No: 97117-234

Subject: Primaax Extreme Maintenance Free Joint

Date: JULY 2011

Revision: A

FIGURE 1

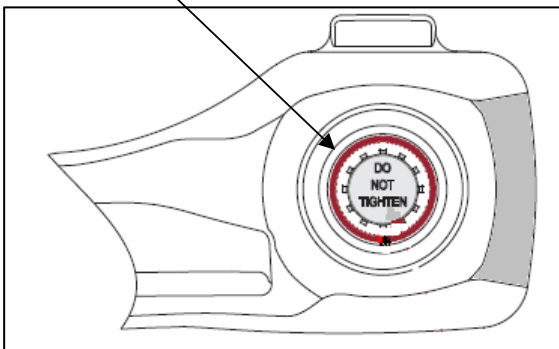
The Primaax Extreme (EX) Suspension Systems currently in service are configured with an integrated end cap. The latest release Primaax EX is fitted with a tamper resistant bolt cover, (Figure 1) whilst the early release Primaax EX is fitted without a tamper resistant cover (Figure 2).

Hendrickson International now advise that all Primaax EX suspension systems, including suspensions fitted without a tamper resistant bolt cover, no longer require a torque check at production, pre-delivery or any other preventative maintenance activity.

The Primaax EX Torque Table (Technical Bulletin 97117-225B) is now amended to reflect the latest preventative maintenance torque requirements. The Primaax EX support beam and cross tube connection preventative maintenance is now restricted to visual inspection only.
